# Office DEPOT

ADDISON, TEXAS

**SITE PLAN**  
 SCALE 1"=30.0'

**COVER**  
 B4-5 SHEETS

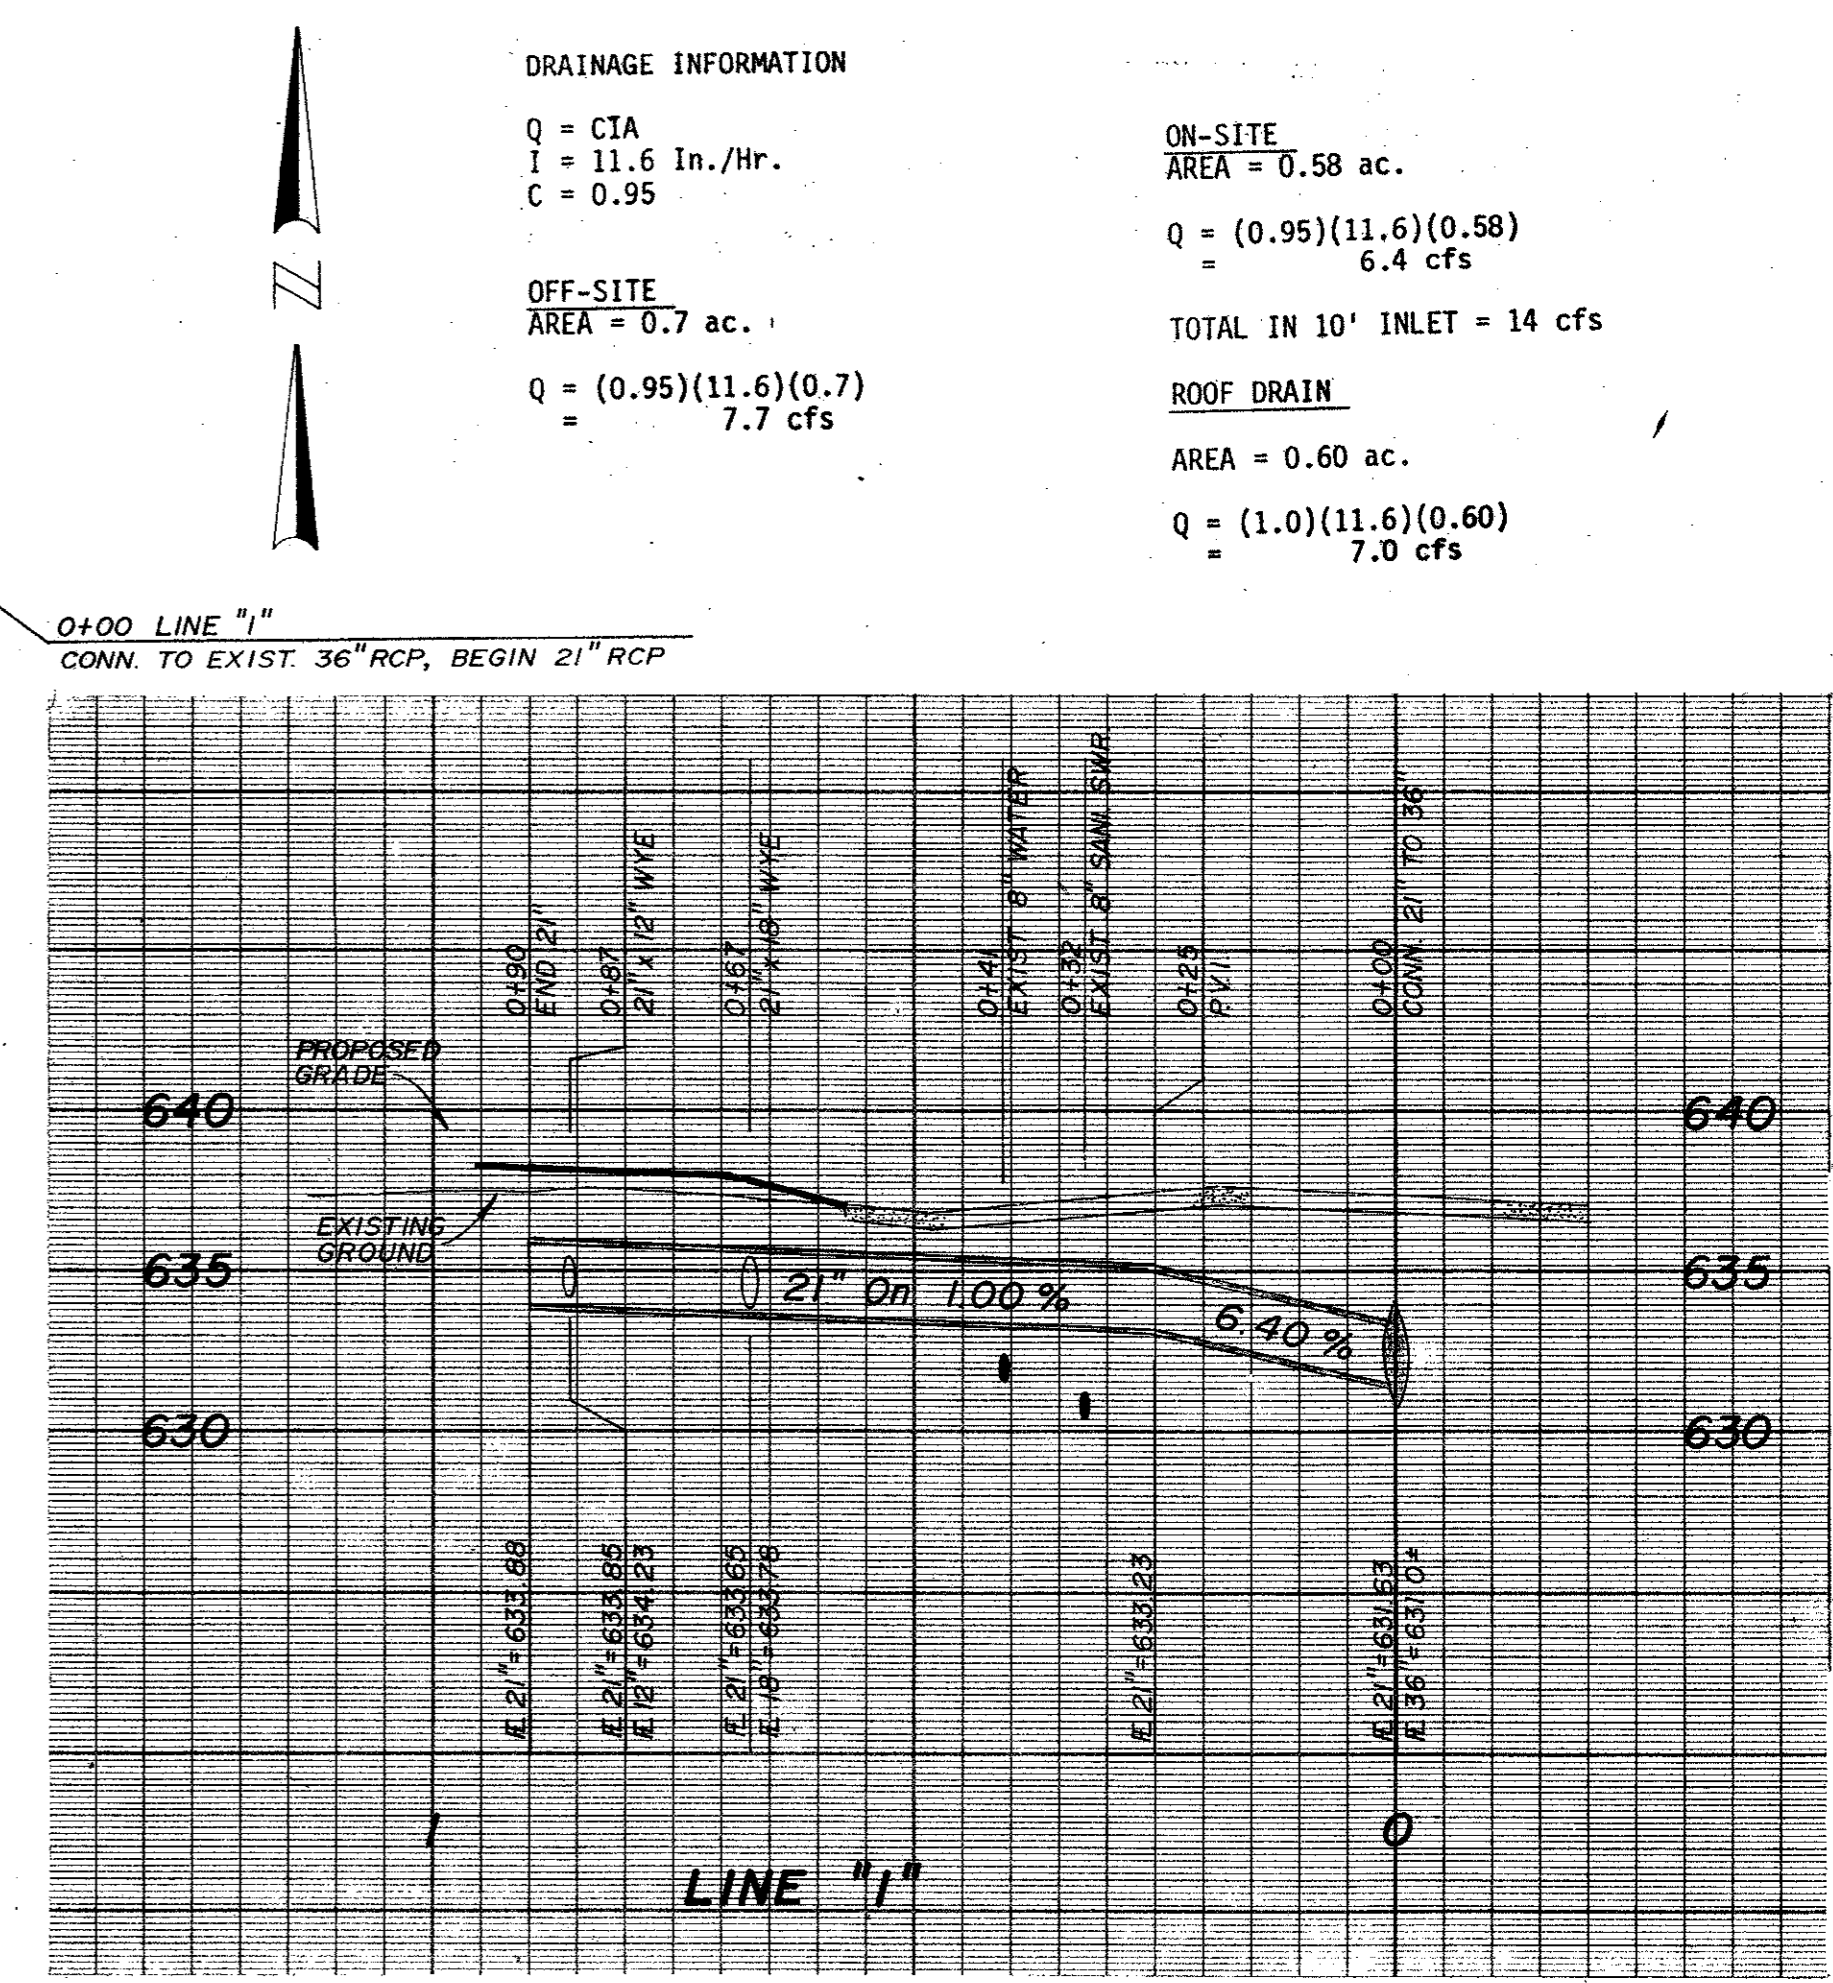
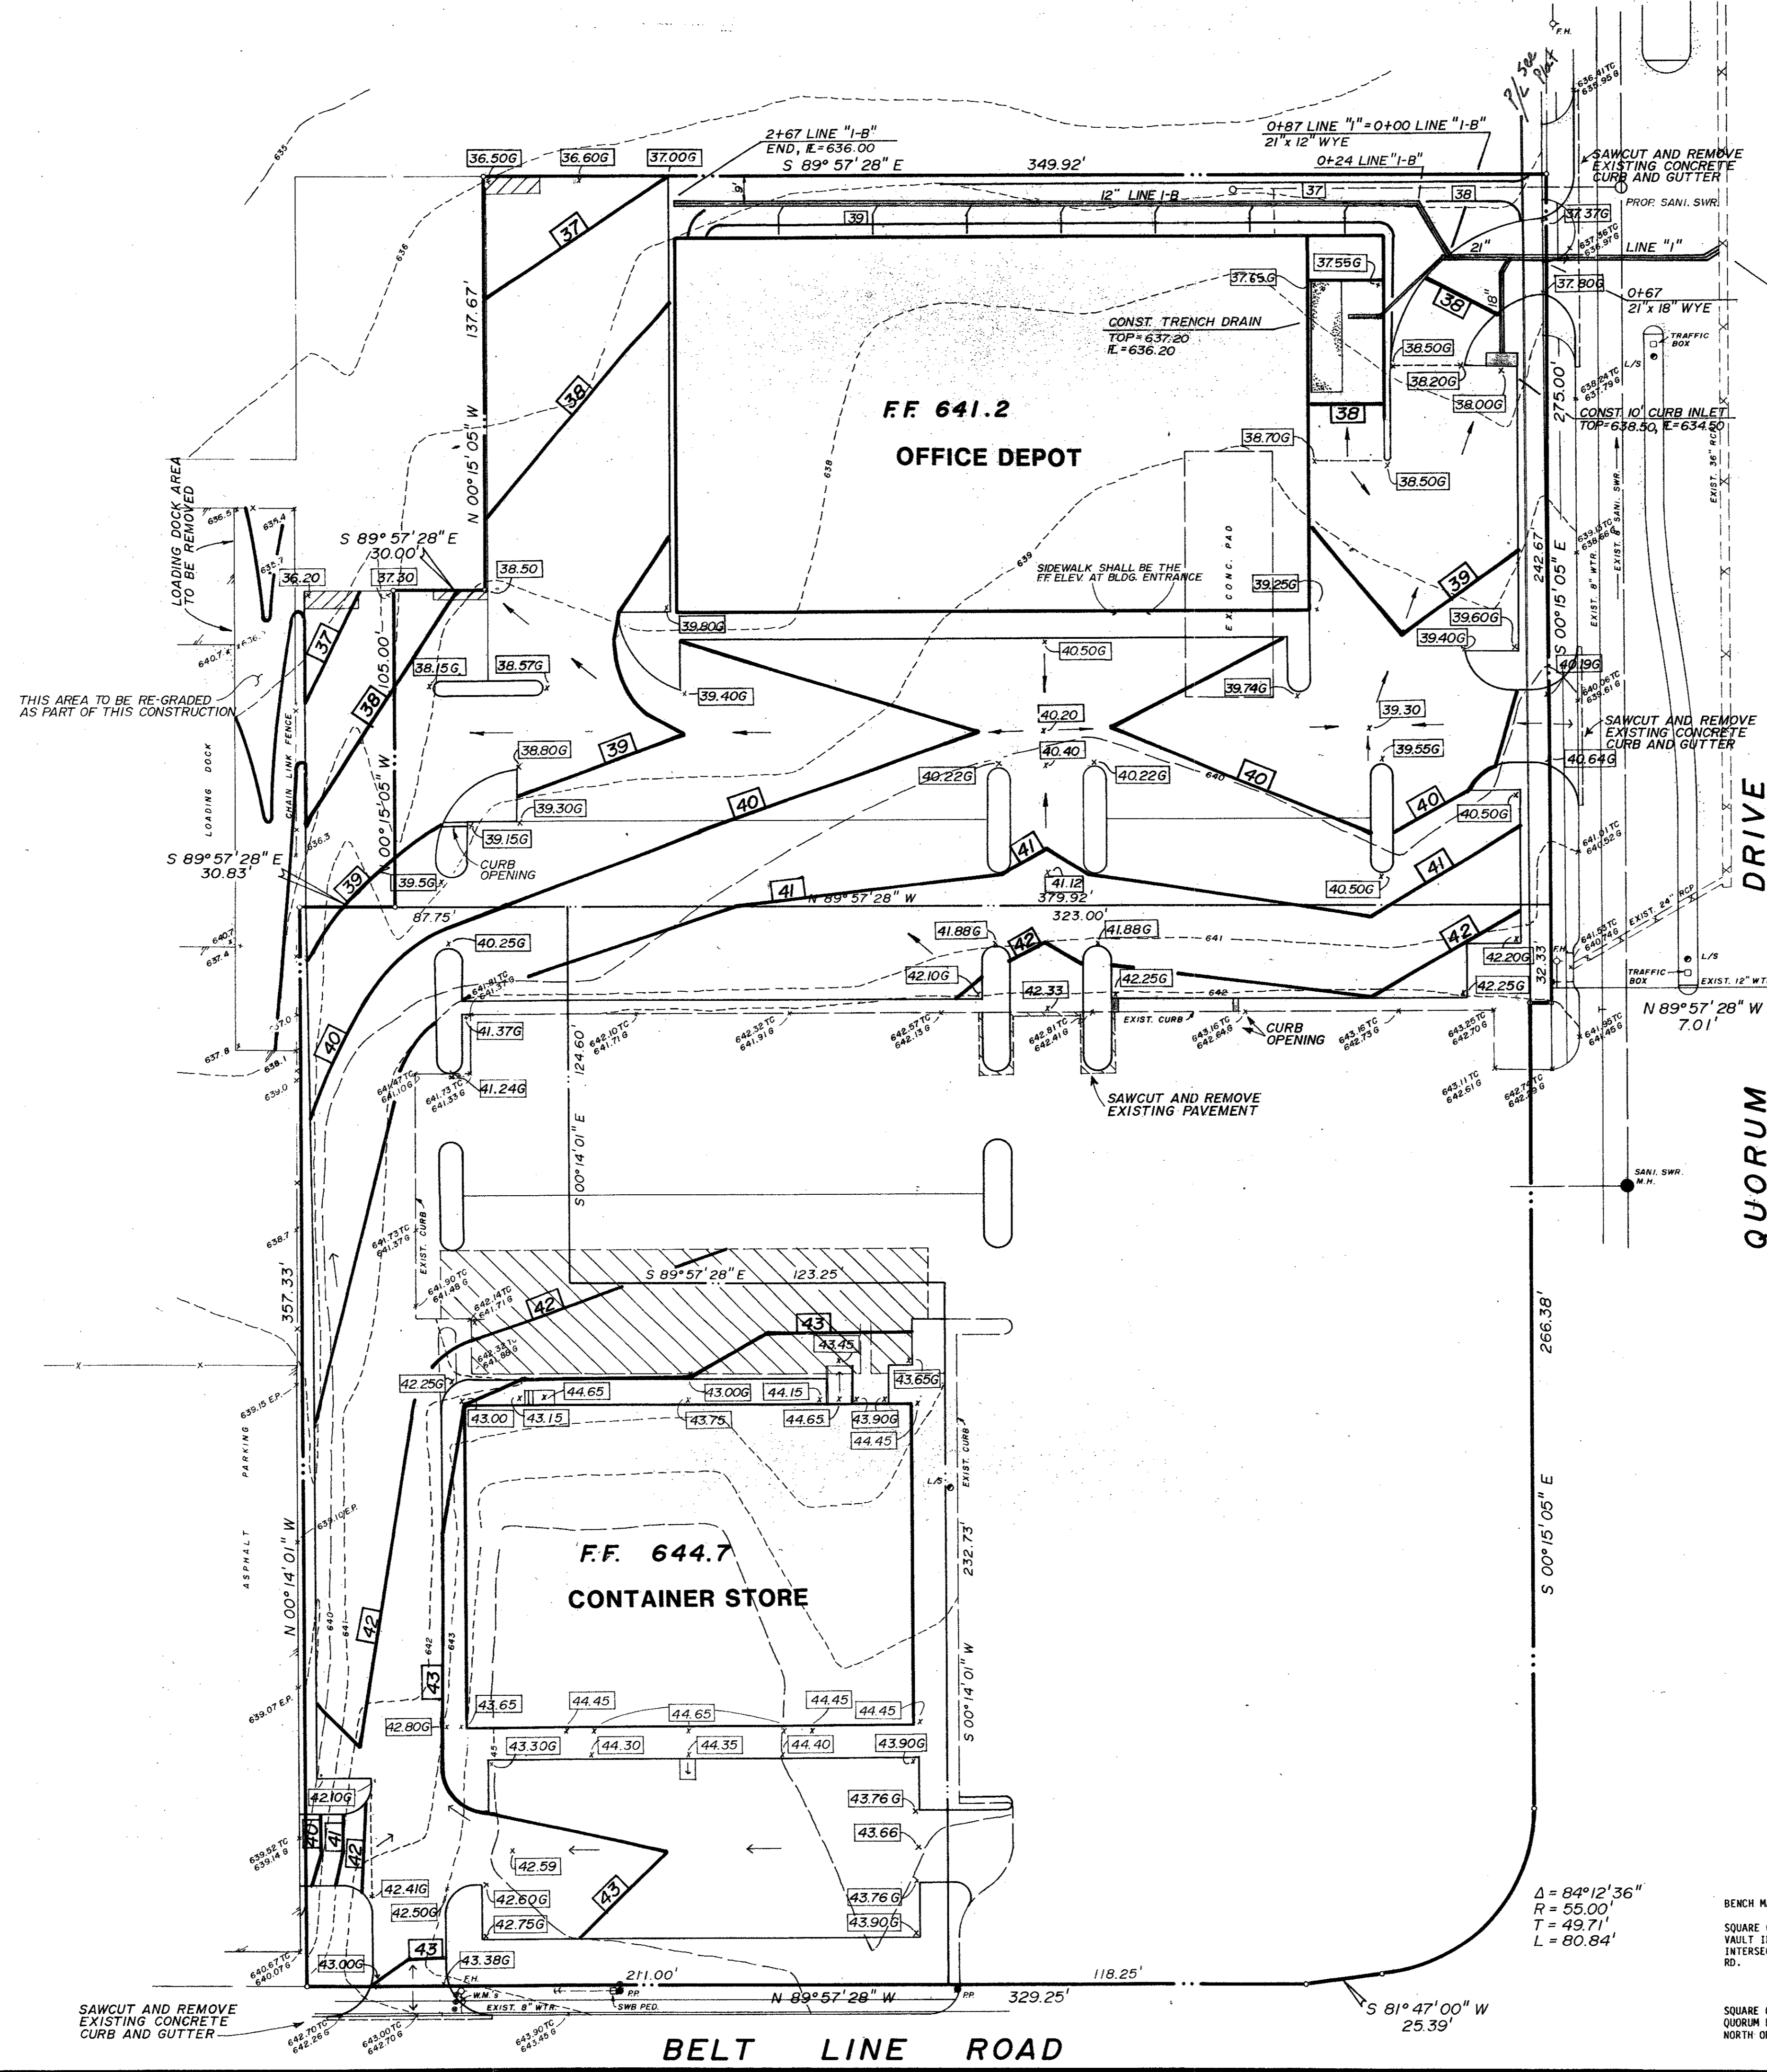
*LANDSCAPE  
 SEE ATTACHED PLAN 11-2-22-9  
 CORRECTED PLAN  
 SEE NOTES ON REVISED  
 ATTACHED LANDSCAPE PLAN.*

BRUCE:  
 IS PRO RATA DUE?  
 WATER TAP FEE \_\_\_\_\_  
 SEWER TAP FEE \_\_\_\_\_

| WATER & SANI. SWR. PLAN                                       |       |        |          |       |         |           |

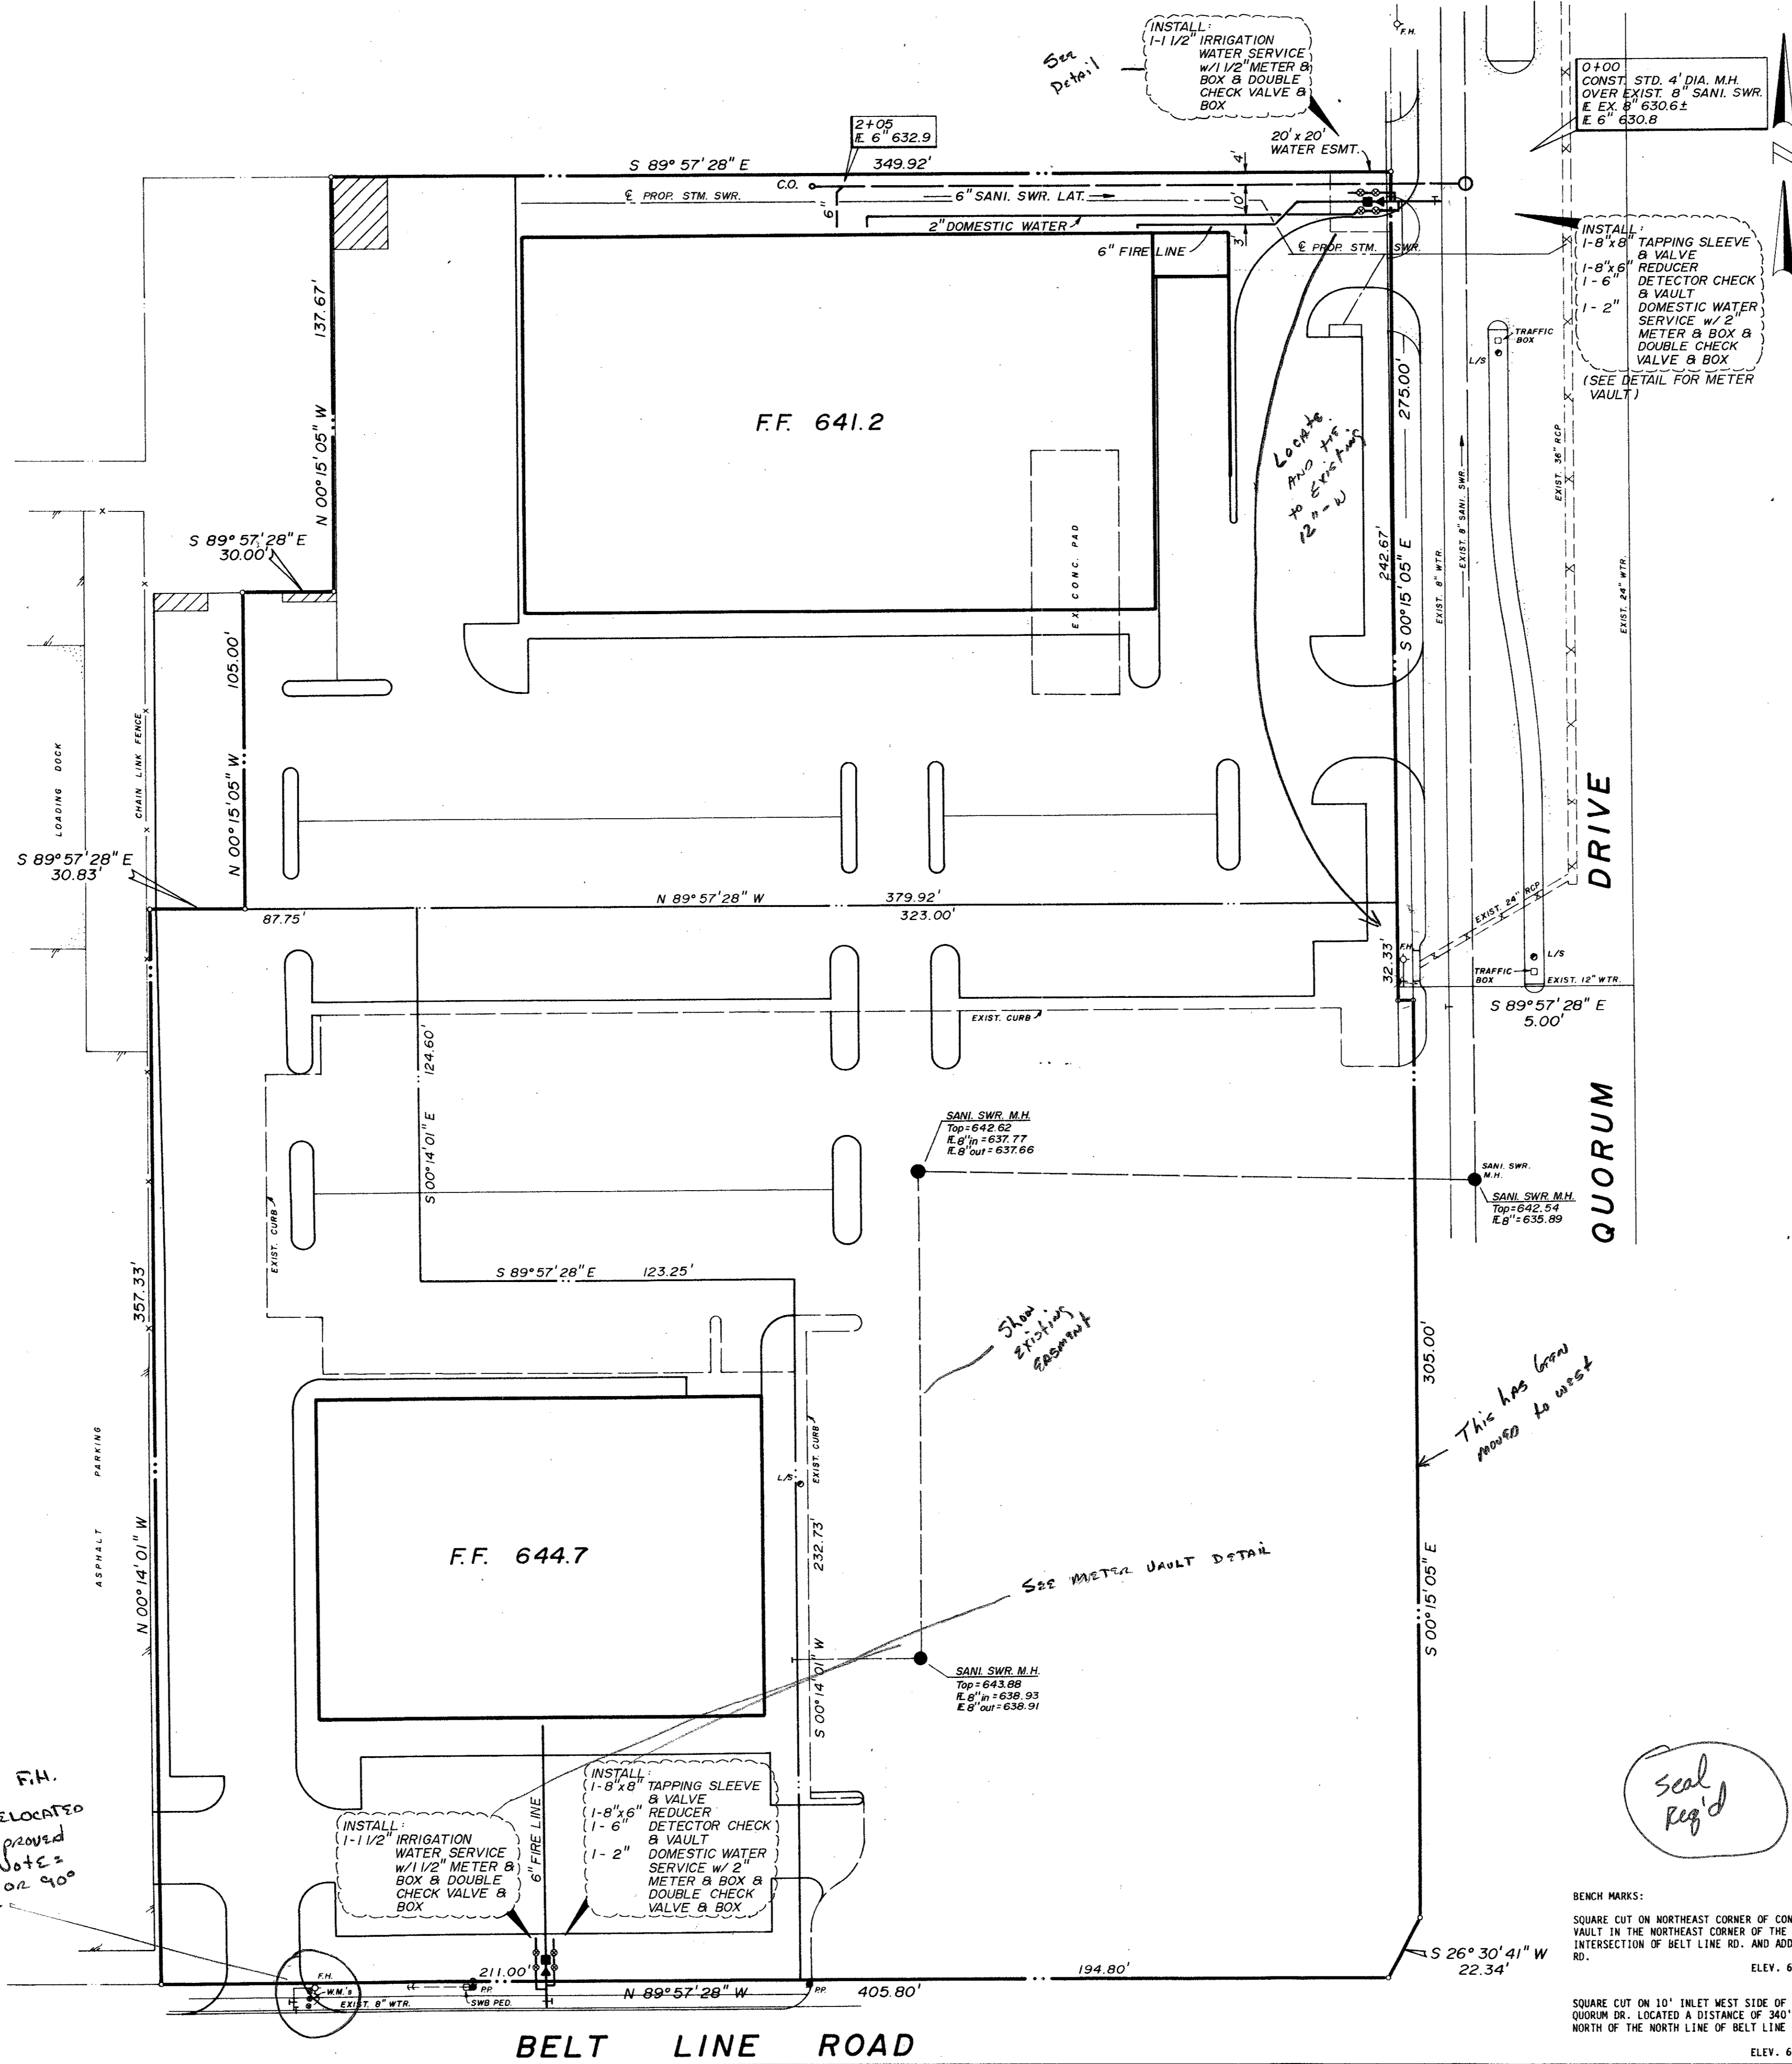
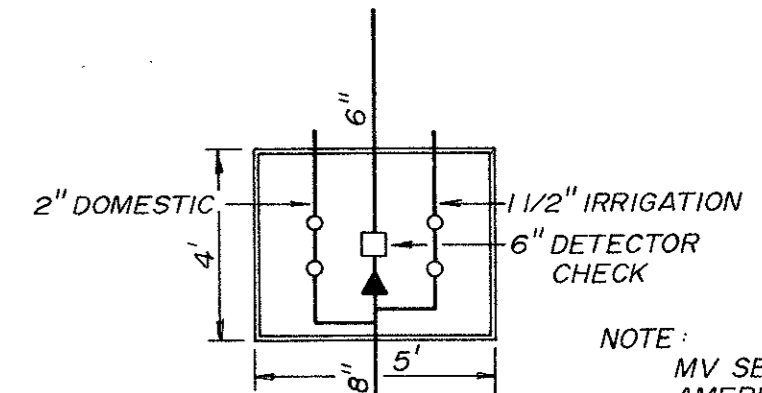
METERS AND F.H. MUST BE RELOCATED TO TOWN APPROVED LOCATION. NOTE: NO VALVE OR 90° BEND EXIST

This has been moved to west

Seal req'd

**METER VAULT**  
ALL METERS AND DOUBLE CHECKS IN ONE BOX - LARGE ENOUGH TO ALLOW COMPLETE ACCESS FOR REPAIRS. USE A Bilco TYPE LID - VAULT NEEDS TO BE CONCRETE WITH CONCRETE FLOOR.
